MEMORANDUM

SUBJECT: Mandatory Referral No. 10701-MCPS-1 Garrett Park Elementary School
Modernization Project, 4810 Oxford Street, Kensington near the Intersection of
Strathmore Avenue and Kenilworth Avenue Zone R-60, North Bethesda/Garrett
Park Master Plan.

STAFF RECOMMENDATION: **APPROVAL** to transmit to Montgomery County Public Schools, the following comments:

Attachment 3 – Existing and Proposed Layout Concept

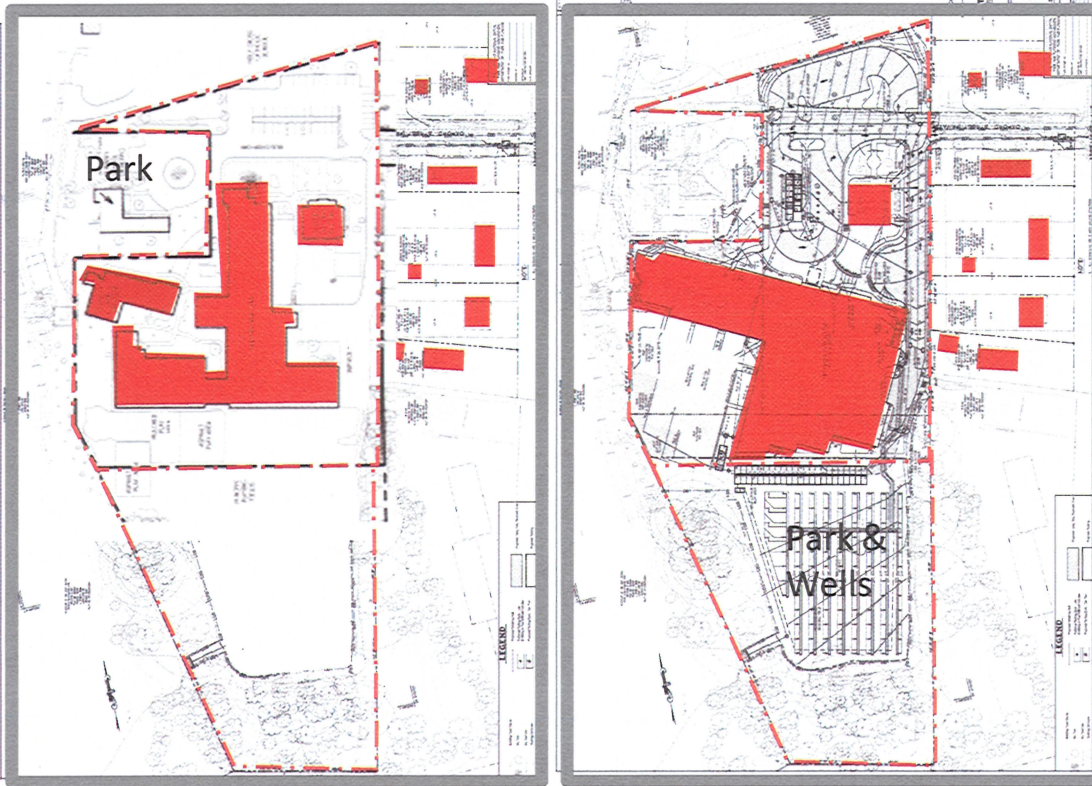
6. Install a fence and additional plantings along the east property line to preserve the privacy of adjacent residents and to screen views of the school and its parking lot. Preserve the mature 24 inch diameter lindens on the north side of the parking lot and the mature 34 inch diameter willow oaks on Oxford Street.

The north edge of the new expanded parking lot with new retaining walls should be redesigned to preserve two mature 24 inch diameter lindens which contribute to the character of the school and shade the parking lots for both the school and the Holy Cross complex.

Two mature 34 inch diameter willow oaks on Oxford Street should be preserved. On-going MCPS and community efforts to preserve these trees are commendable. Planning staff will continue to support this effort as issues related to placement of WSSC facilities are addressed to reduce impacts on the trees.

Additional trees are recommended along the eastern edge of the school site to preserve the privacy of the adjacent residences, to replace trees being removed by MCPS and to filter views of the taller school as described earlier. Most of such trees may be best sited on the adjacent private property due to space constraints on the school site. MCPS has already requested and received permission from several property owners to remove and replace trees that will not survive the impacts of the construction on the school site.

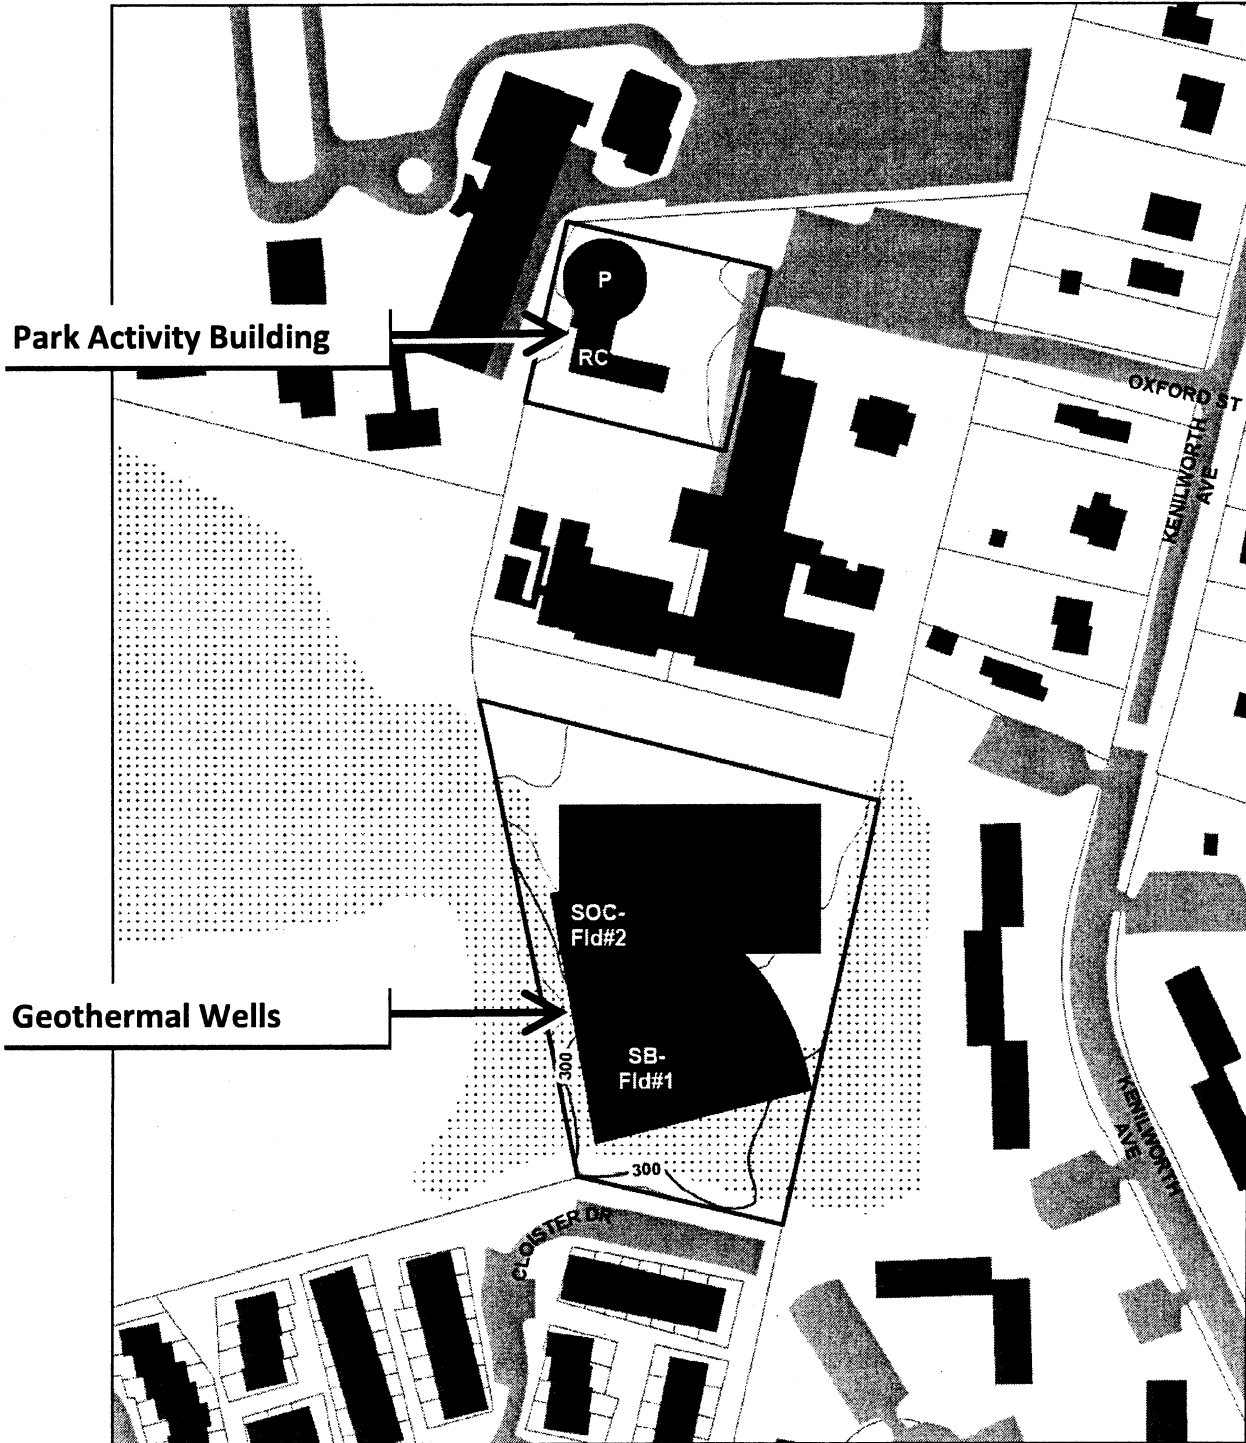
A component of the reconstruction is geothermal well heating and cooling technology. The 120 wells will be drilled vertically to a depth of approximately 400 feet and will be located underneath Softball Field Number 1 at Garrett Park Local Park (GPLP) as illustrated in Attachment B. The extent of excavation and the lack of adequate access for maintenance, public safety and policing will require the entire park to be closed during the well drilling, installation, and field restoration period.

- Parks authorizes the installation of approximately 99 geothermal heat pumps (vertical ground loop systems) on the existing MNCPPC athletic field behind the Garrett Park Elementary School (GPES).
- Geothermal well installation will be sequenced to maximize time for field restoration.
- Parks will allow the installation of stormwater management underground detention vaults and a stormwater outfall behind the school on Park property. Plans and specifications must be approved by MCDPS.
- Parks approves the geothermal well layout as illustrated in Attachment B that minimizes impact to tree critical root zones.
